DUKE COGEMA
STONE & WEBSTER

Subject: Docket Number 070-03098
Duke Cogema Stone & Webster
Mixed Oxide Fuel Fabrication Facility
Response to Request for Clarification

Enclosure A

Enclosure A
 CAR Figure 5.4-1 to CAR Information Cross Reference Table

Figure 5.4-1: Safety Assessment of the Design Basis

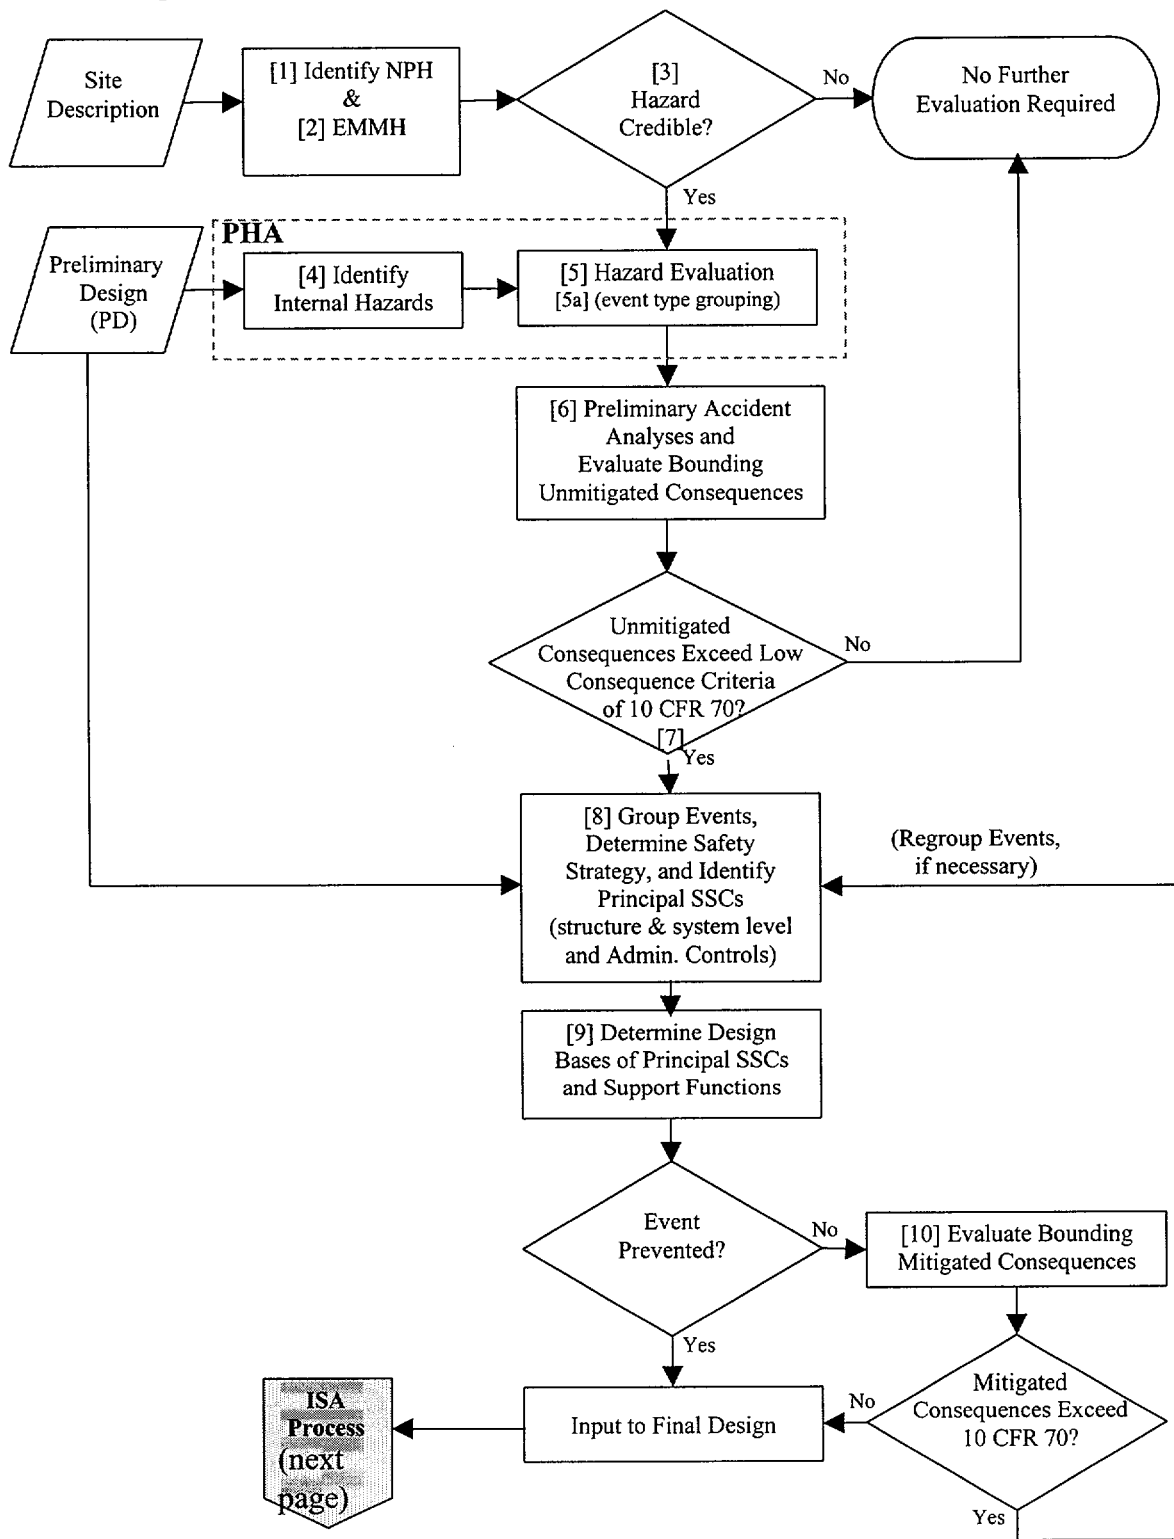
During review of Duke Cogema Stone & Webster's (DCS') Mixed Oxide Fuel Fabrication Facility (MFFF) Construction Authorization Request (CAR), NRC staff requested a clarification of the ISA process described in CAR Figure 5.4-1 that correlates the figure to the tables in CAR Chapter 5 and the internal supporting documentation. This correlation is provided in Enclosure A. If you have any questions, please contact me at (704) 373-7820.

The attached figure provides a cross-reference from the actions in Figure 5.4-1 to the tables in chapter 5 and the supporting DCS calculations. Sample hazard identification, hazard evaluation, and consequence evaluation sheets are also provided for information.
